HIGHWAY 24 EASTGATE BUSINESS PARK

A CONDOMINIUM PLAT OF LOT 3, HILLCREST ACRES

BUILDING NO. 2

Plat Drawing_V1.pdf Markup Summary

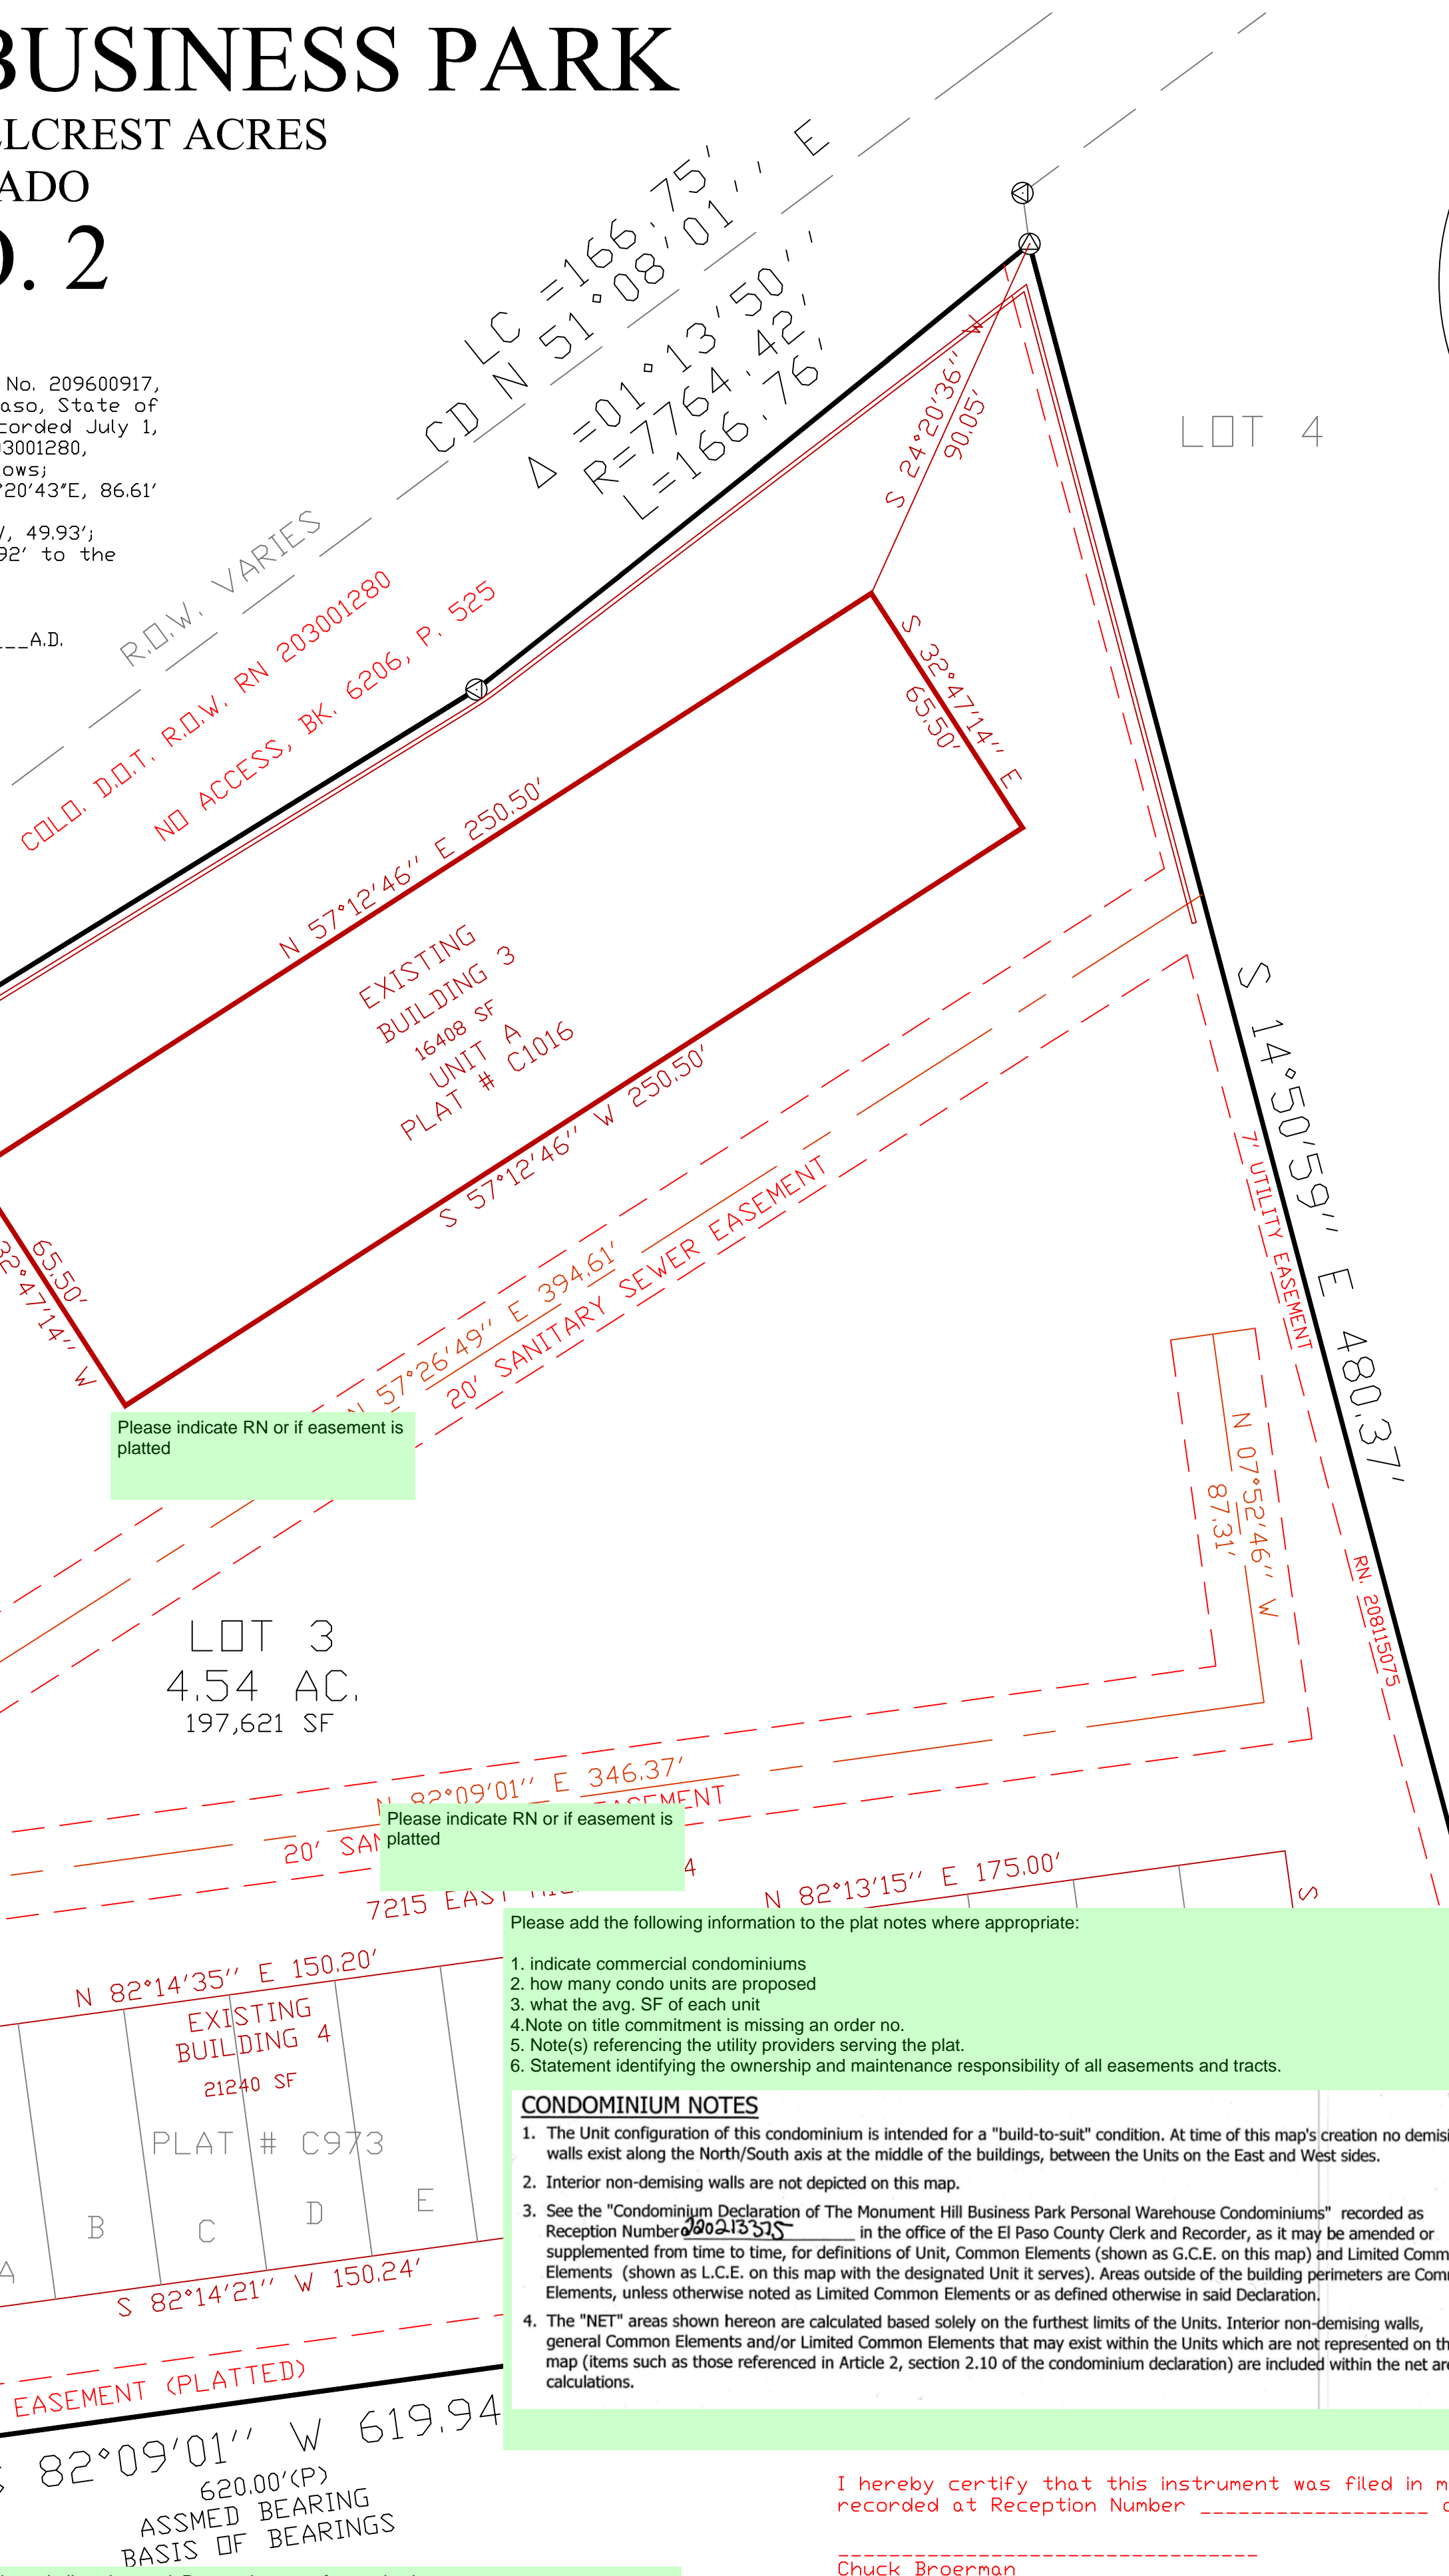
Please indicate RN or if easement is platted

Please indicate RN or if easement is platted

edge
